DESCRIPTIVE REPORT

Type of Survey Hydrographic
Field No. RA-10-25-97
Registry No. H-10776

State Alaska
General Locality Northwest Prince William Sound
Sublocality Main Bay and Approaches

Descriptive Report to Accompany Hydrographic Survey H-10776

DP 50312 taken approximately in this position

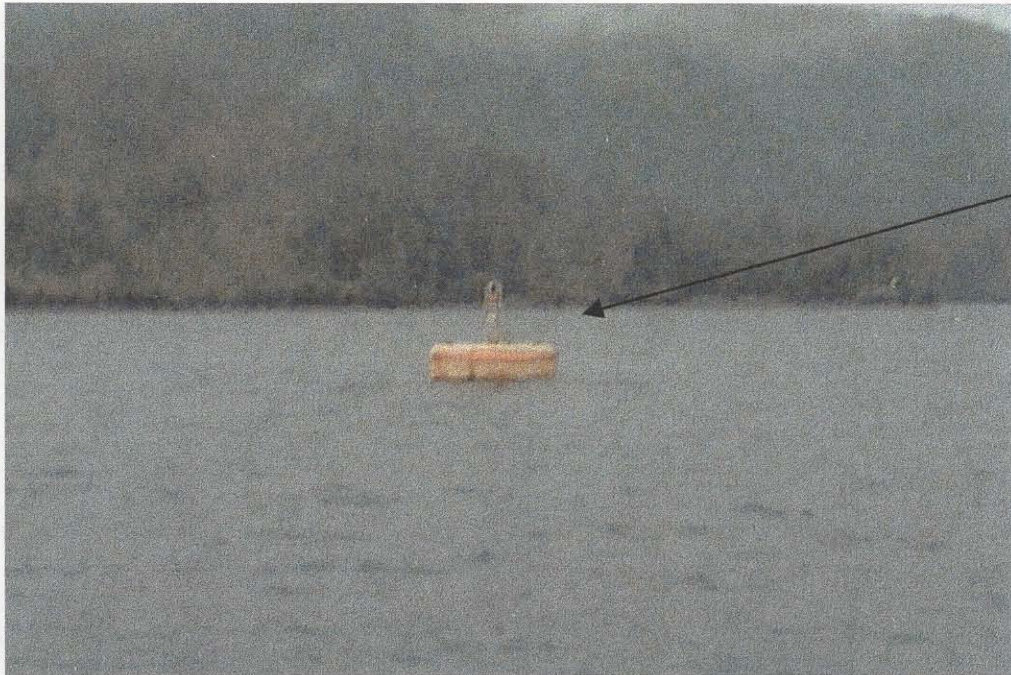
New pilings at 60-35-12.86 N, 148-06-54.46 W (DP 50312) should be charted. See picture below. *-concur New piling are located approximately 500 meters south of charted pile. Un-charted Pilings at DP 50312 ✓*
